Interactive comment on “Flash flood occurrence and relation to the rainfall hazard in a highly urbanized area” by K. Papagiannaki et al.

ANSWERS TO REFEREE COMMENTS We would like to sincerely thank Martin Mergili and the anonymous referee for the constructive comments that helped us to improve the presentation and the overall argumentation and quality of our paper. Following the reviewers' comments and suggestions we proceeded to a careful revision of the article. In more detail, the following changes have been made in accordance with the respective comments:

Fig. 1. Figure 1. Map of target area and locations of surface meteorological stations. Stations are named by the municipalities they are located in.

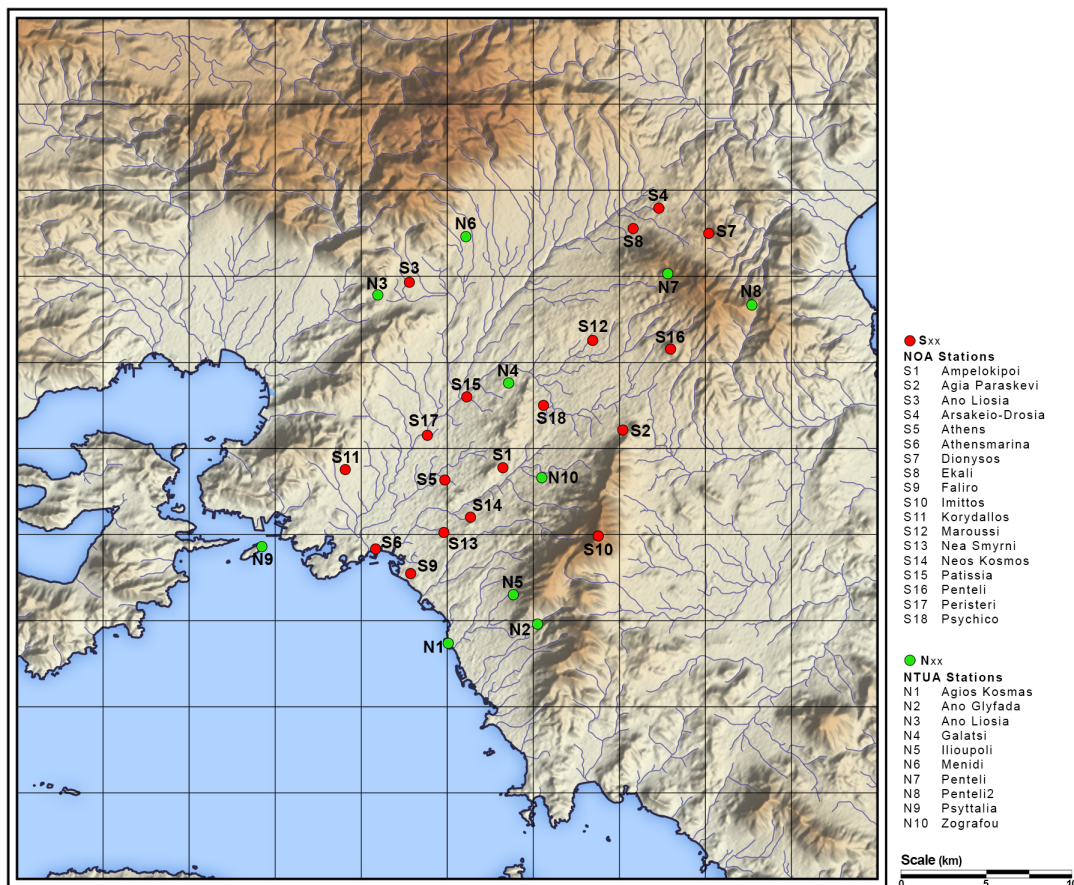
5. 'As the article concerns both natural and socio-economic issues, it would be good if you could add the most important towns (if possible, as areal signatures) to Fig. 1. Further, the green and red symbols should be shown also in the legend (even though it is clear what they mean)'

[4-5]. ‘P. 3123, l.23. Two paragraphs before it appears the same sentence “The target area of this study is the most urbanized and densely populated department of the prefecture of Attica”. I would remove one of them. P. 3125, l.15. You say here that 48 flash flood events affected the target area, but in the previous page you say that 91 FF affected Attica. In order to avoid any confusion I suggest to show in Figure 1, the limits of the Attica Region and the target area.’

11. 'Figure 1. You could reduce the region presented in the figure and increase the size of the numbers and the corresponding stations. I am afraid it won't be clear for the readers'

Green and red symbols have been added in the legend as suggested. In what concerns the towns, we believe that a greater size of the picture would be required for a clear printing of the respective names. The legend of Fig.1 lists the meteorological stations, which are named by the municipality in which they are located. Therefore, we added in the caption an explanation about the origin of the stations' names. Main municipalities are also shown in Fig.2, in which, as explained in section 3 'Methodological issues': 'The name of each area derives from the respective municipality that covers the major part of it.'

Section 2 has been revised based on both referees’ suggestions. The section has also been enriched with the addition of an informative comment regarding the new user-friendly website of the National Observatory of Athens designed by the authors, which provides a geographical presentation of the high-impact weather events in Greece, including the flash flood events analyzed in the present article (<http://www.meteo.gr/meteoplus/weatherevents.cfm>). In what concerns Figure 1, when the size of the target area is decreased then the location and labeling of stations becomes very small. Figure 1 is however revised following the 11th specific comment of the referee.

The size of the number has been increased as suggested.

Fig. 2. Figure 2. Division of Athens-Suburbs region in 15 sub-areas. The representative rain gauges in each sub-area are also shown with red (NOA stations) and green (NTUA stations) bullets.

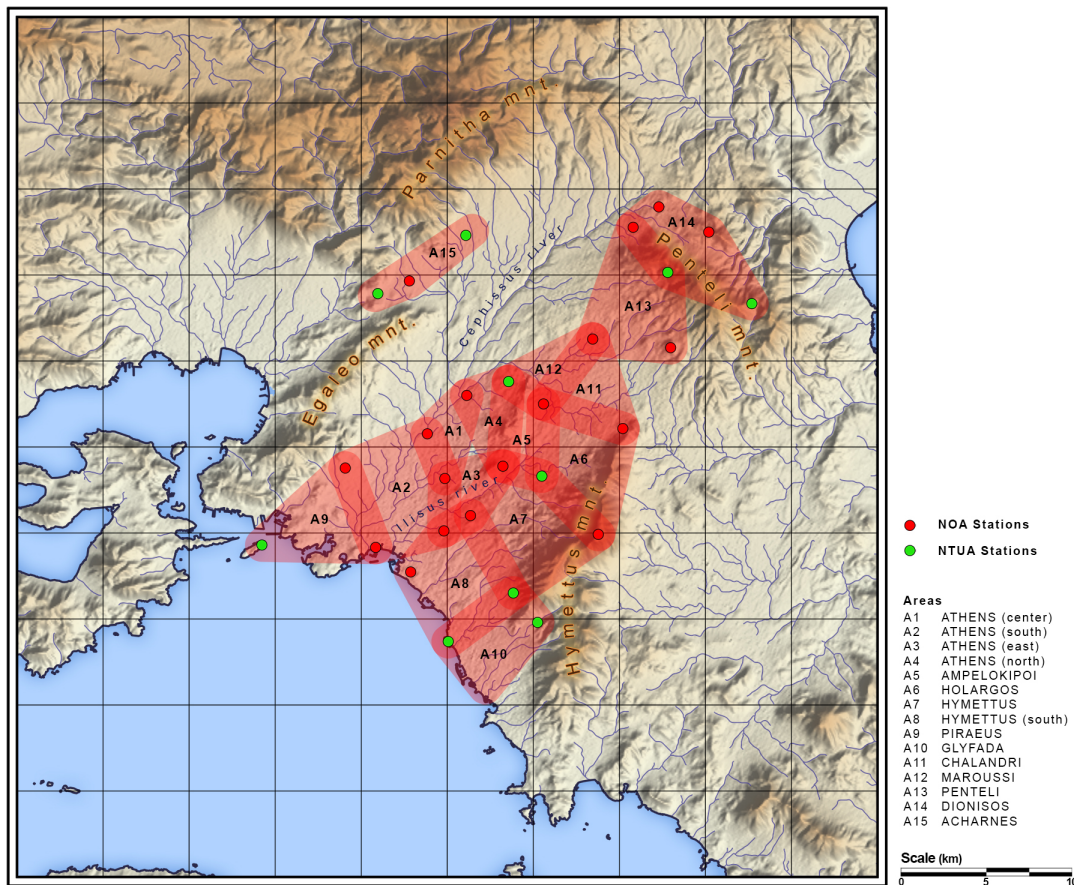
4. 'Figs. 1–3 need a scale bar (alternatively, you may mention the grid spacing)'

Figures have been revised according to the suggestion.

Fig. 3. Figure 3. a) Number of flash flood events per sub-area.

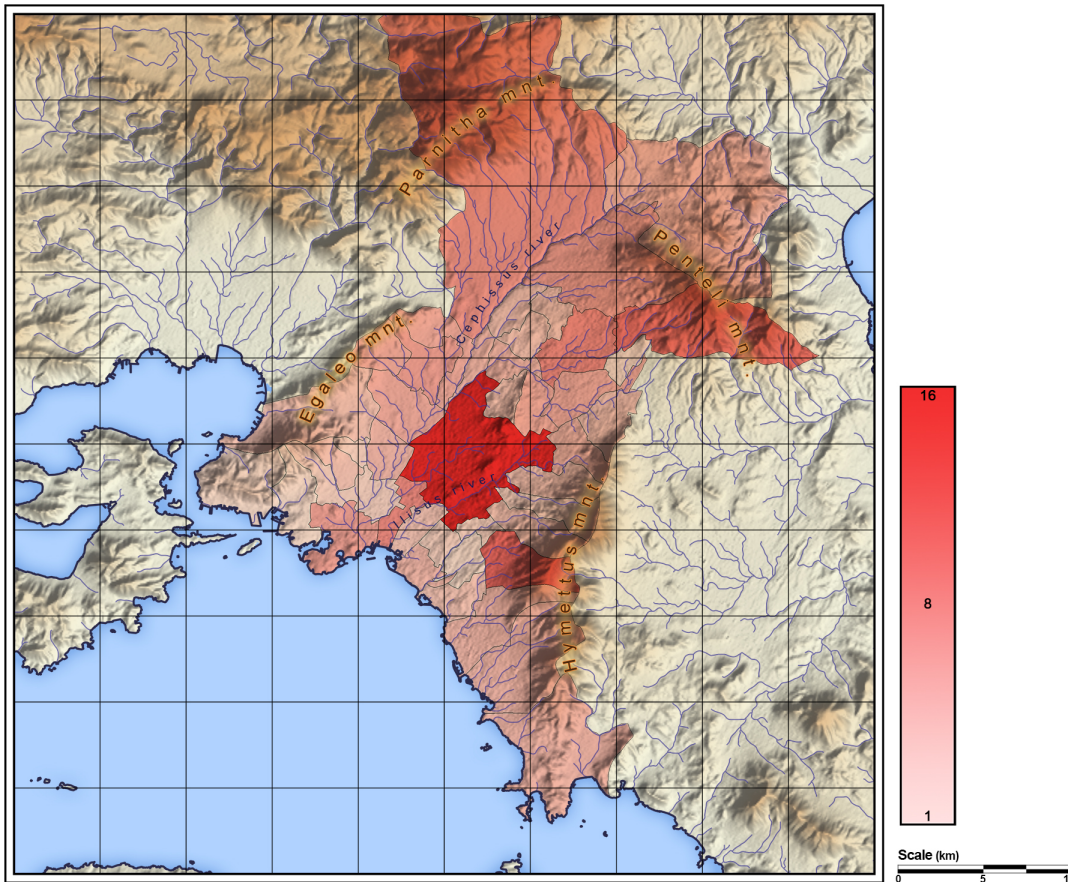
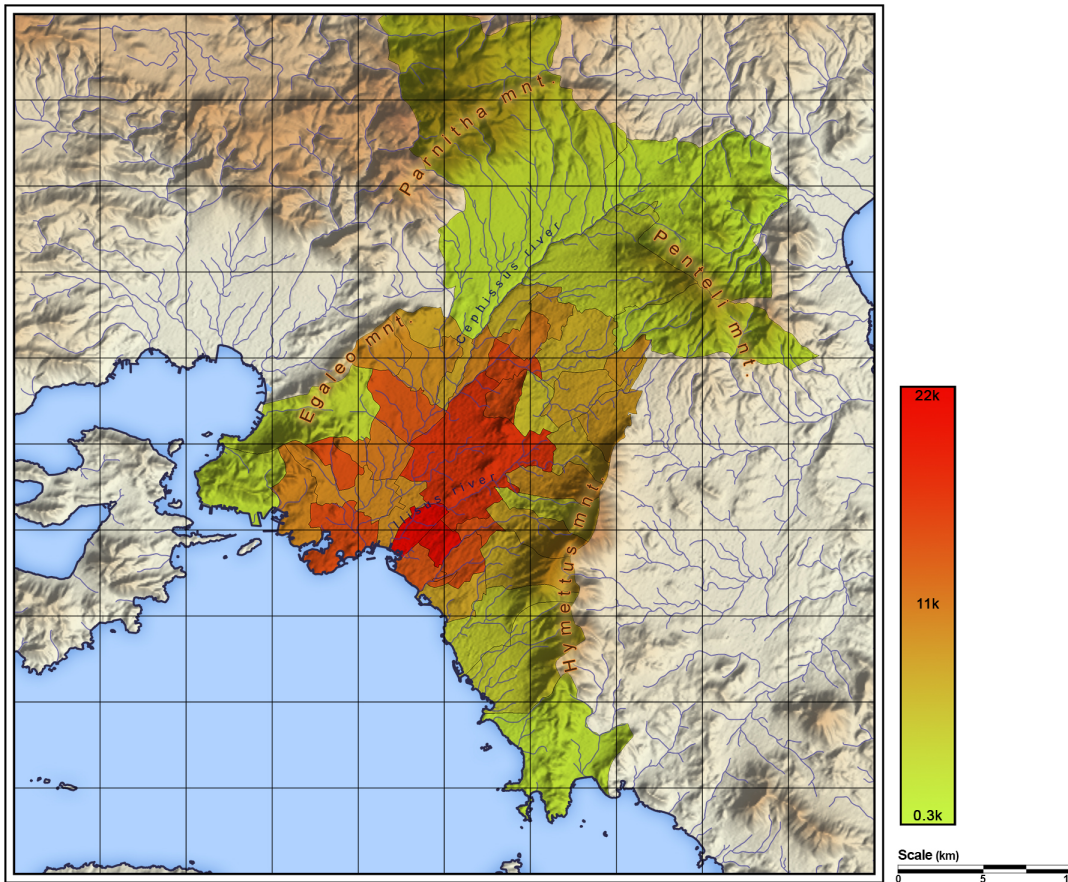
12. 'Figure 3 has not legend explaining the colours meaning.'

The caption of the figure has been revised.

Fig. 6. Figure 4. Quantile distribution plots for b) R10 observations. Fraction of data relates to the number of Fire Service operations.

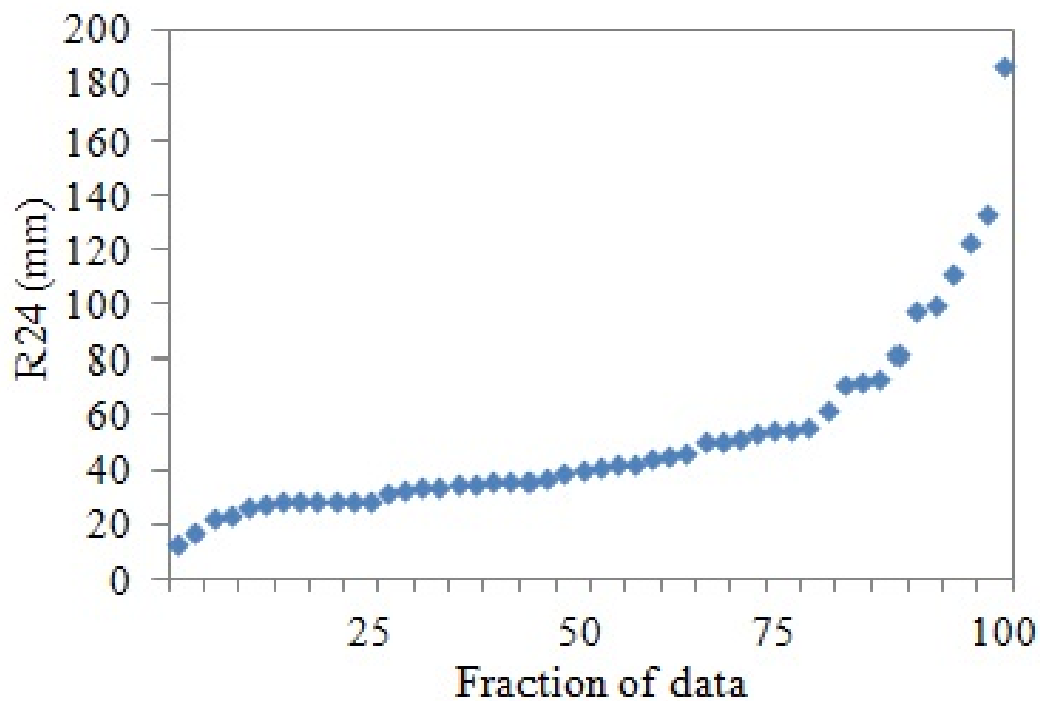
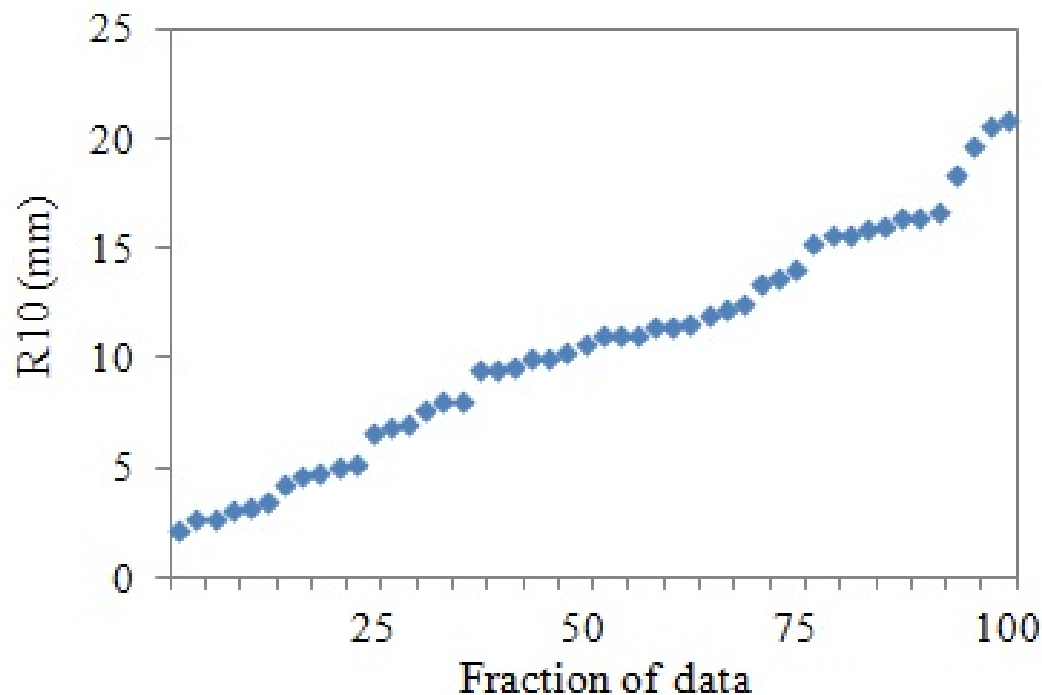
6. 'Fig. 4: I think that the y axis label of the right pane should be replaced by "R10"? In fact, the two figures look very similar, probably the right one has to be replaced by another one at all ... Further, you should write in the caption that the fraction of data relates to the fire brigade reports'

The reviewer correctly observed that the Fig.4b is the wrong one. We replaced it by the correct one. The caption has been also revised according to the suggestion.

Fig. 7. Figure 5. Number of events, Fire Service operations and average number of operations per event for various ranges of (a) 24-h (R24)

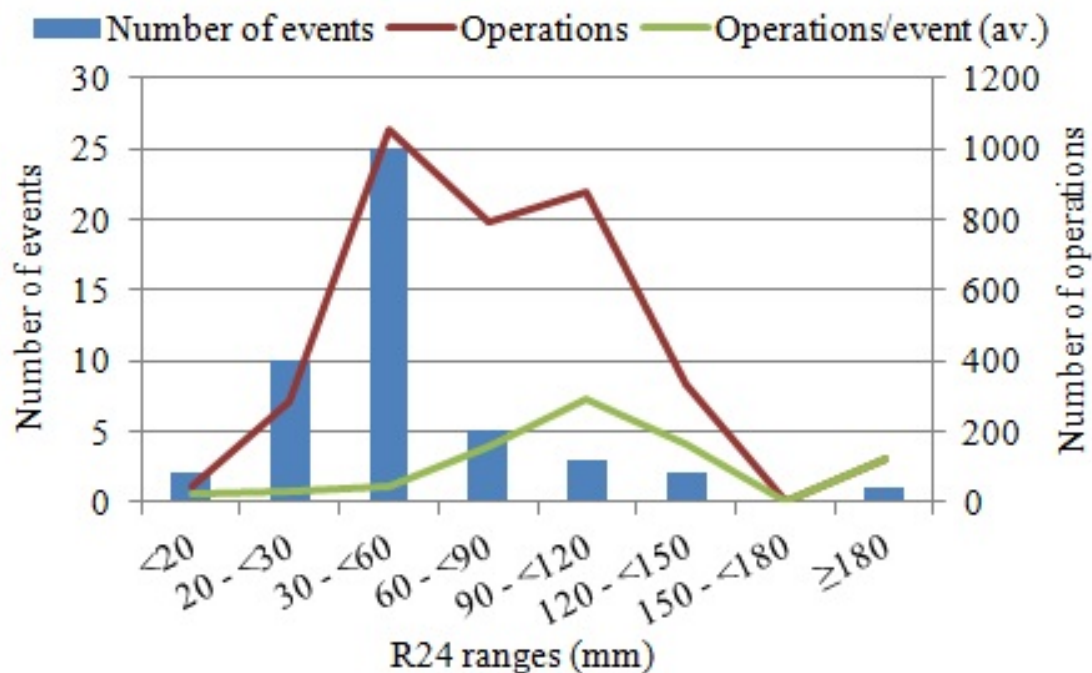
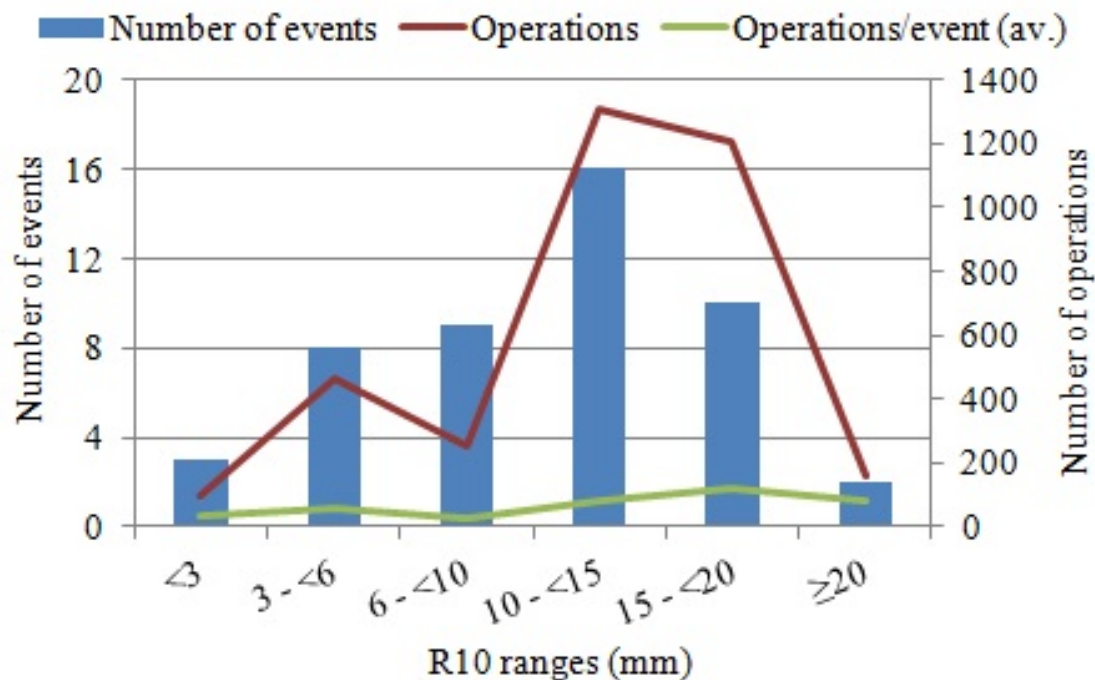
7. 'Fig. 5: Be careful, the x axis tick mark labelling is incorrect. E.g., R24 of 30 mm is actually assigned to two classes, this is not allowed. 30 – <60 mm, 60 – <90 mm etc. would be correct'

8. 'Figs. 5 and 6: It might be good to show a graph relating the number of events and the number of the fire brigade operations (e.g., building a ratio between the two). However, it is the decision of the authors whether they would like to try doing so.'

The figures have been corrected according to the suggestion.

The ratios operation/event for various ranges of 24-h (R24) and 10-min (R10) accumu-

lated rainfall is discussed in the text, section 4.1. Figures 5a,b have been revised to include the respective data, according to the suggestion.
